1 UNITED STATES OF AMERICA
2 NUCLEAR REGULATORY COMMISSION

3
4 ADVISORY COMMITTEE ON REACTOR SAFEGUARDS
5 SUBCOMMITTEE ON CLASS 9 ACCIDENTS

9 Thursday, August 28, 1980

12 The purpose of the meeting is to discuss hydrogen
13 generation and control. This represents an interesting
14 departure from the usual in that we spend much of our time
15 discussing the more complicated atoms, and I guess we have
16 learned our lesson and we are going to start now looking
17 more at simple atoms, and perhaps we can solve that problem.

Figure 1. Uniform mixtures in the Sequoyah containment vessel.

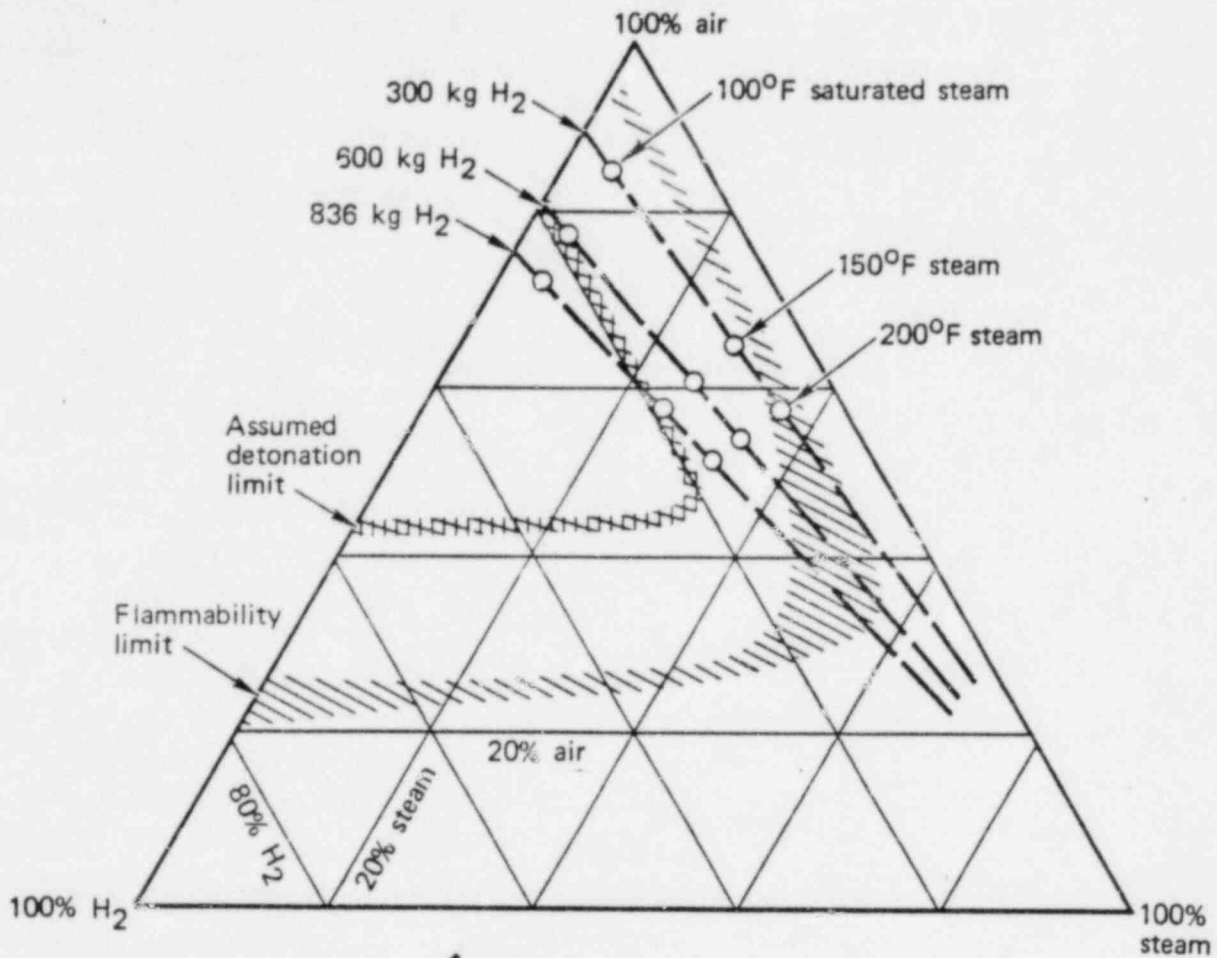
1. a) 300 kg of H₂ gas mixed uniformly with the air and steam (if less than 40 percent steam) in the Sequoyah containment volume following an accident would be completely combustible if ignited (see Figure 1). This complete combustion could occur so rapidly as to exceed the capacity of the available heat removal processes, and could produce a pressure as high as 5.5 atmospheres, thus rupturing the containment (see Table 2). The combustion of 600 kg of H₂ would of course have more severe consequences.

- b) A nonuniform distribution of 300 kg of H₂ present in the containment would consist of parcels of gas richer in H₂ than the uniform distribution. If these separated parcels formed while the blowers were operating, they would probably be mixed, combustible and perhaps detonable. If they were all detonable and all ignited, the damage to the containment would be worse than that due to ignition of a uniform mixture. If the gas parcels were not detonable, the pressure upon combustion would probably be at least as high as the uniform distribution. Under some circumstances, it would be possible to collect pockets of gas too rich in H₂ to burn. As the outer edges of such pockets mix with air, partially combustible mixtures would form. The results of igniting such a distribution would clearly depend on the sizes of the parcels and the timing.

It should be noted that harmless mixtures of H₂, air and steam may become highly combustible or detonable as steam is condensed out (see Appendix B). Thus one mechanism employed for removing heat from the containment also removes the combustion inhibitor from the containment.

Figure 2. Locus of state points for mixtures of 40,000 cfm air with the hydrogen yield of various Zr reaction rates.

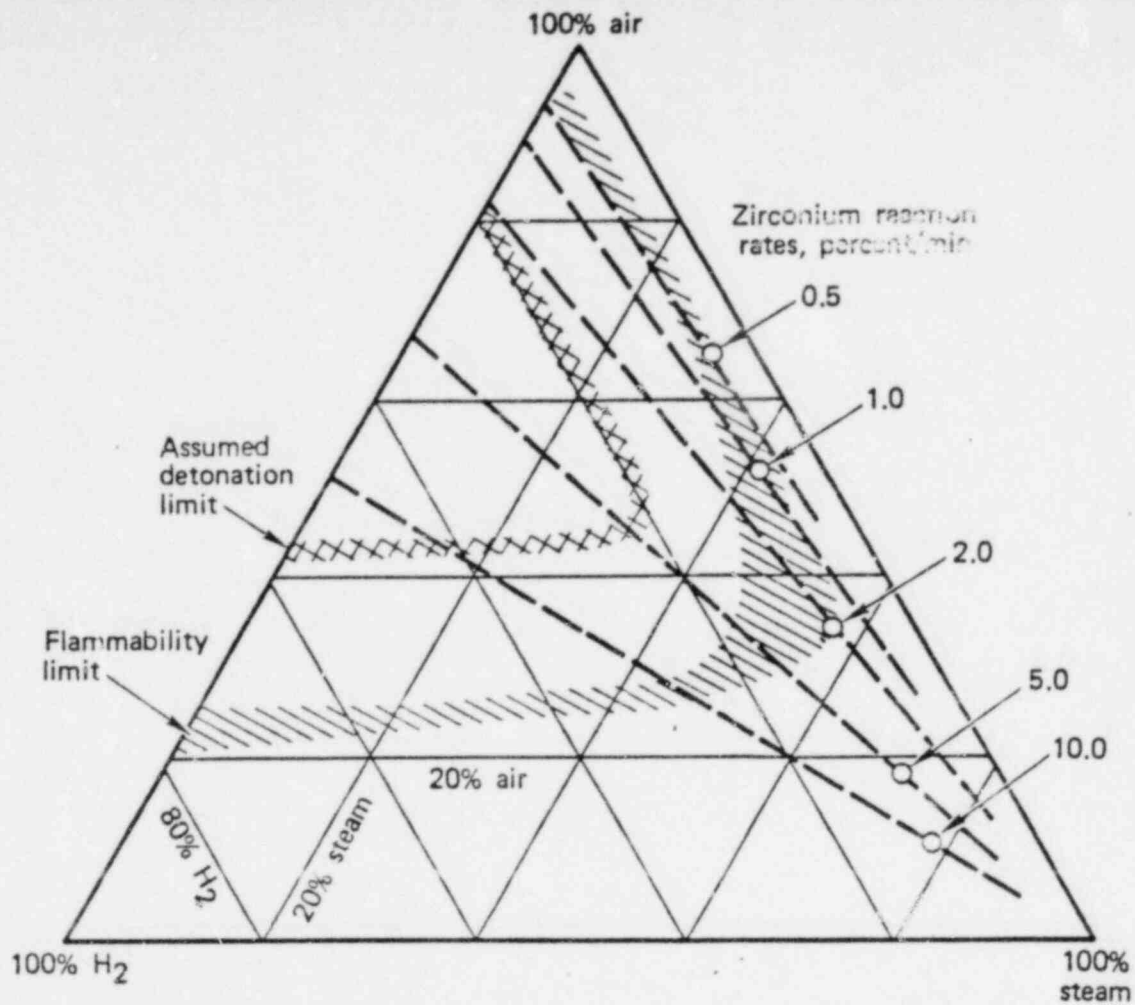
A reference calculation is illustrated in Figure 2, where mixtures of 40,000 cfm air and the hydrogen yields of various rates of zirconium reaction are plotted on the ternary mixture chart. Each reaction rate corresponds to a straight-line locus, with steam rate determining the position on any line. The one point plotted on each line is for a steam rate that corresponds to the heat release rate of the Zr-H₂O reaction and the latent

heat of vaporization of water. It can be seen in Figure 2 that the yield of Zr-H₂O reaction rates in excess of 2% per minute can produce detonable mixtures with 40,000 cfm of air if the steam content is sufficiently low. Rates of several percent per minute were calculated for some accident scenarios in WASH 1400.
